MASTER DEVELOPMENT DRAINAGE PLAN FOR JAYNES PROPERTY

CCES Responses

> Job No. 1305.02 PCD File No. SKP-225

COMPOSITE % IMPERVIOUS & COMPOSITE RUNOFF COEFFICIENT CALCULATIONS

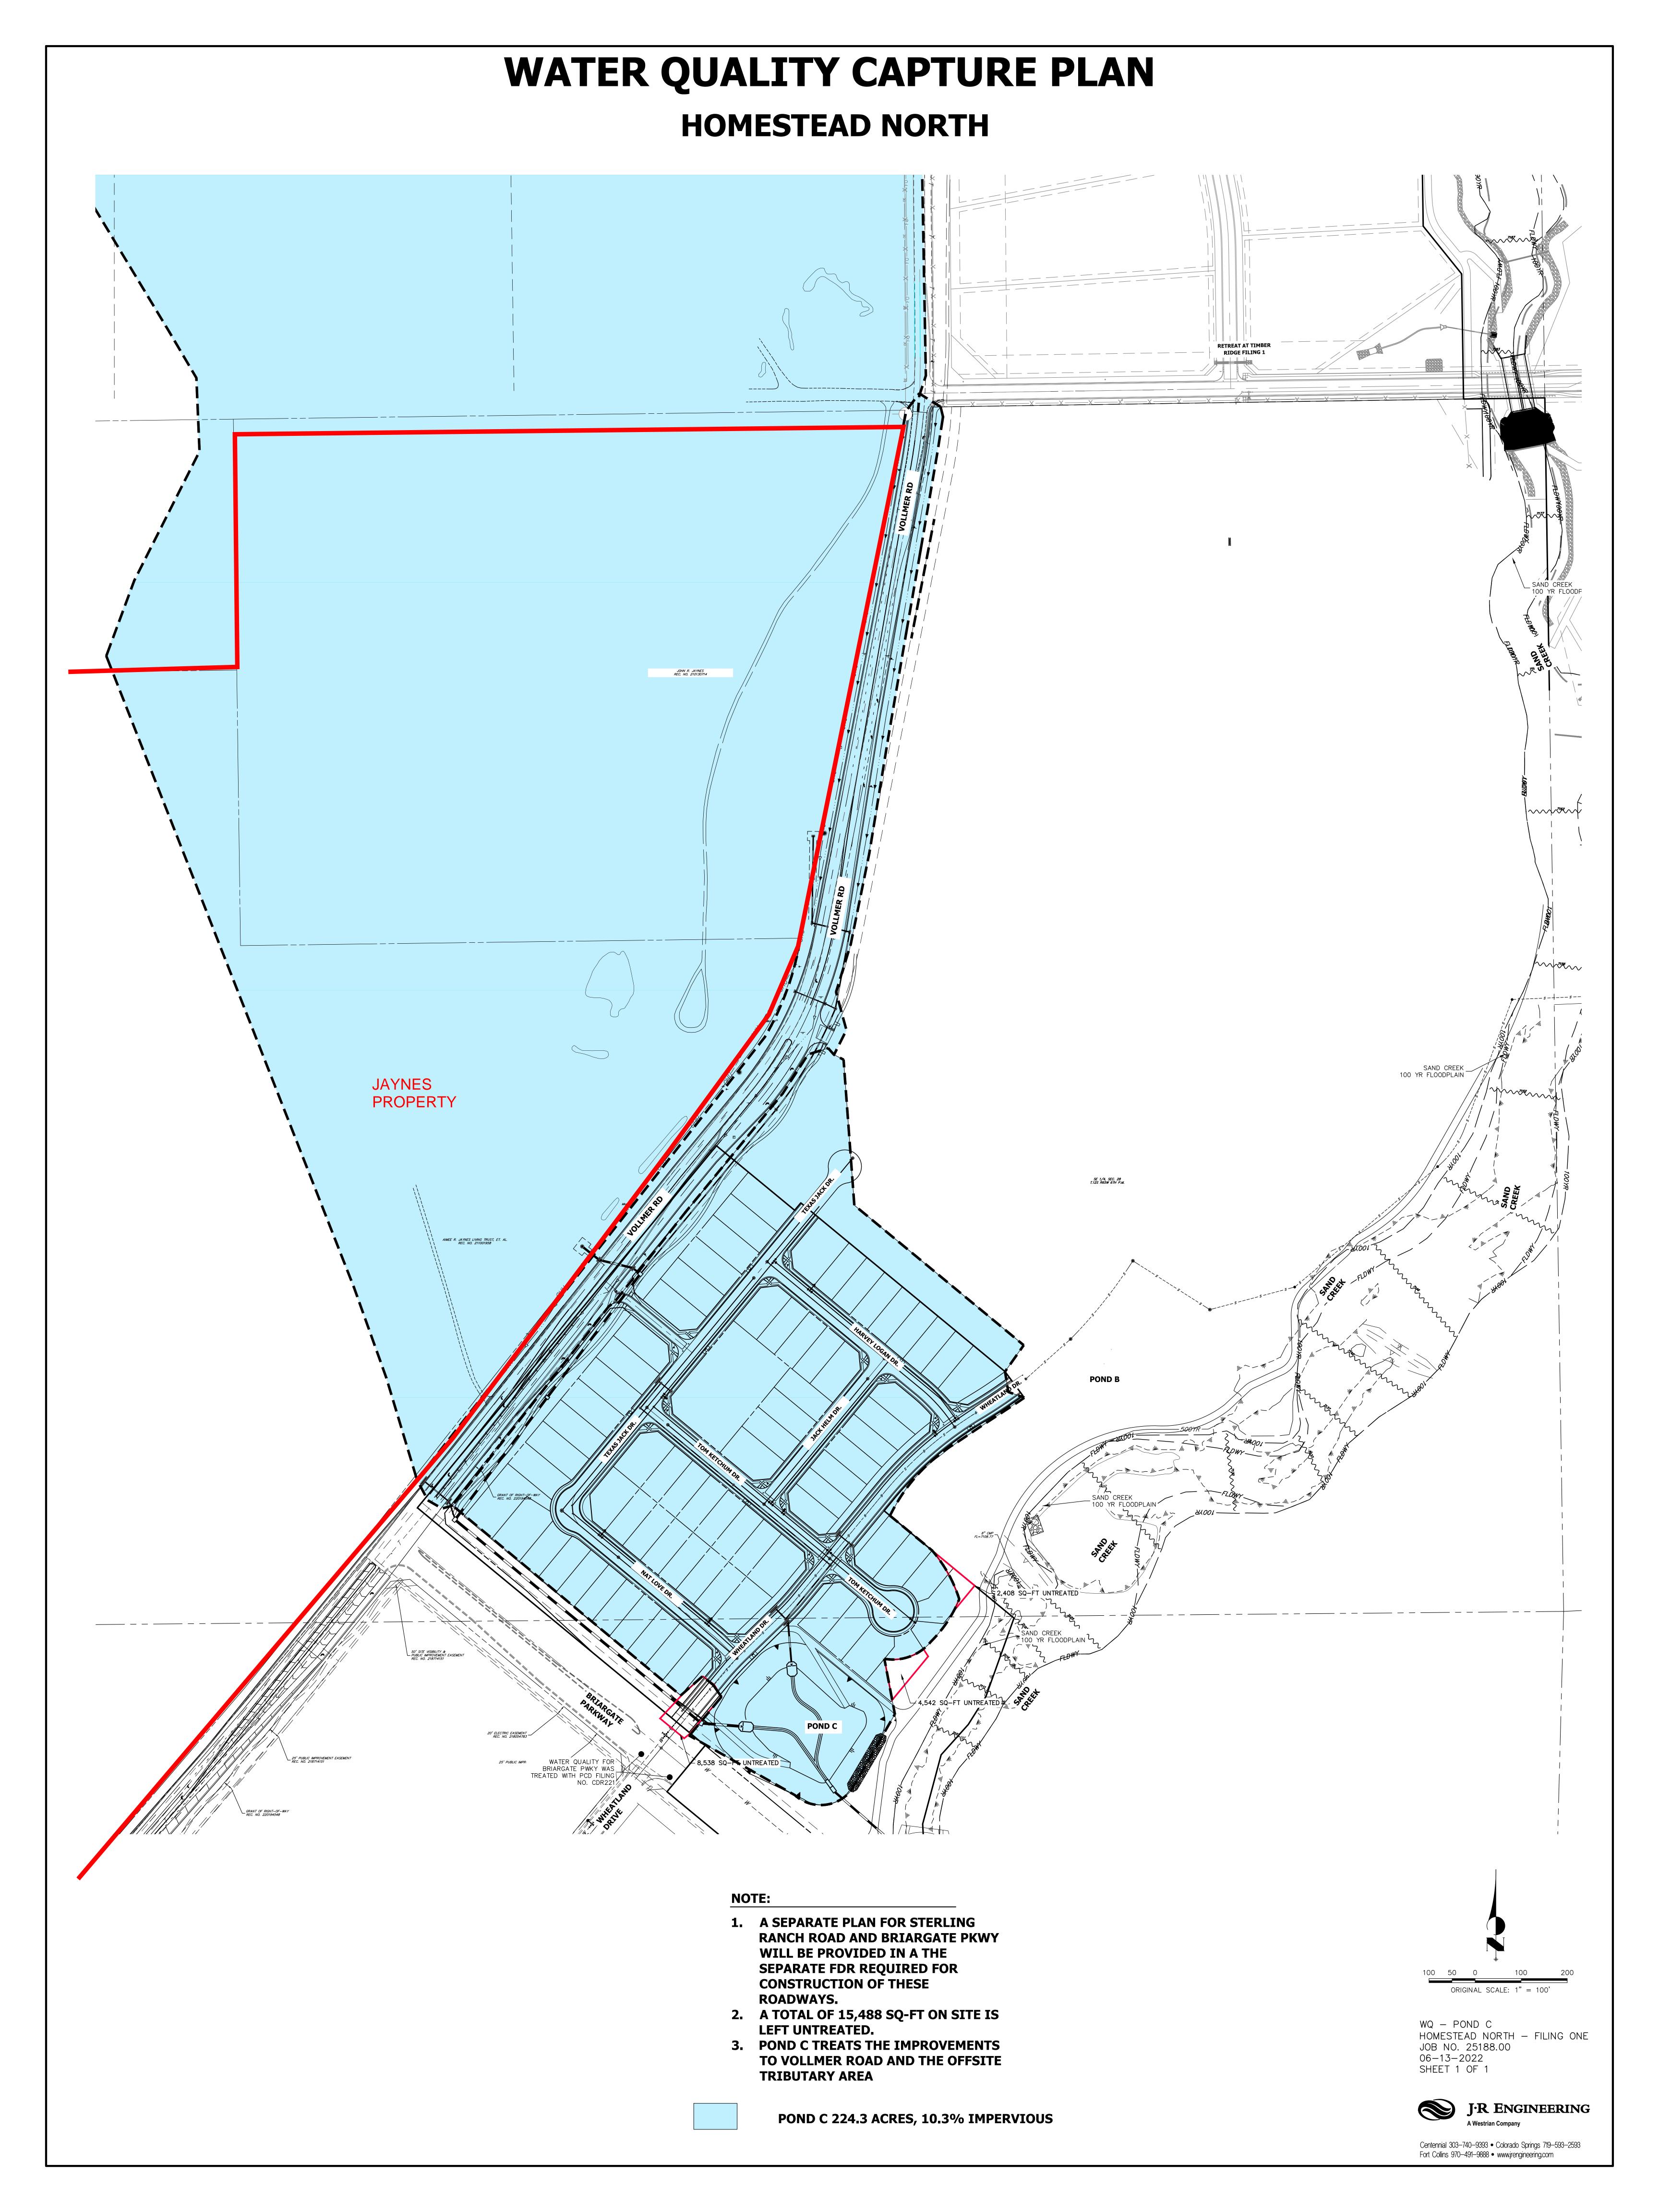
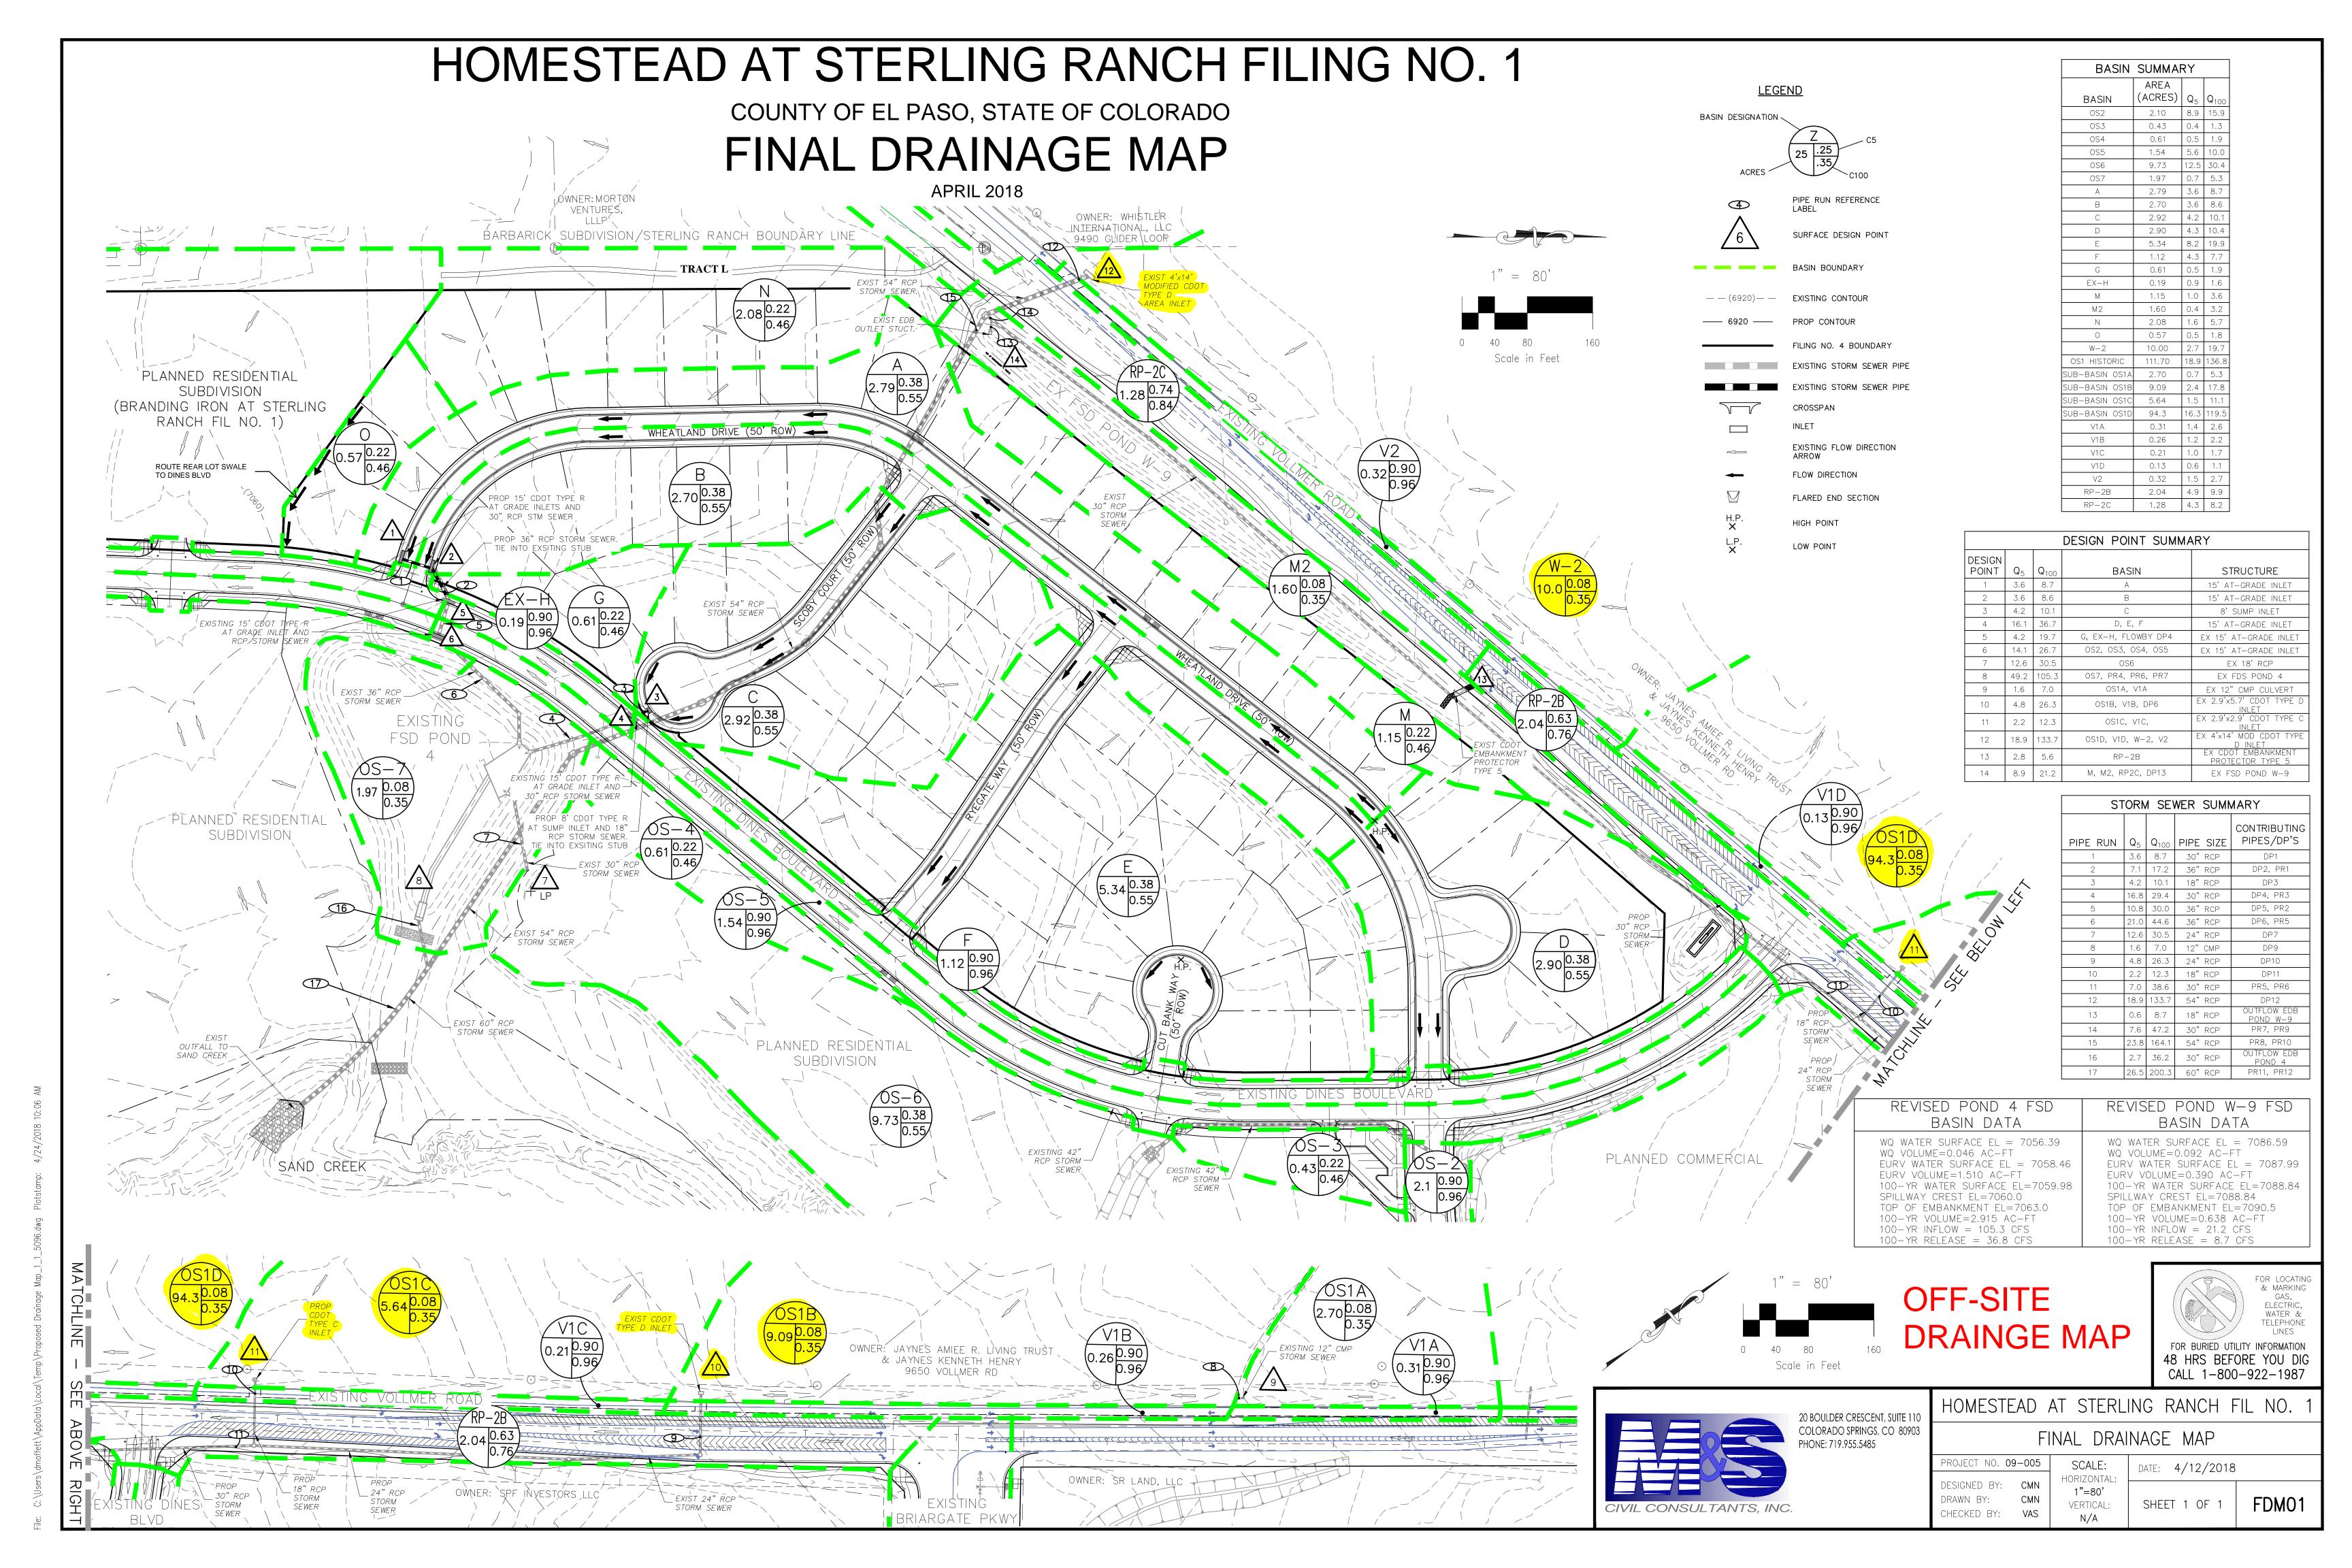
This is all undeveloped. Provide Pond C calculations with total developed imperviousness as well.

Added additional language and comparison chart to narrative
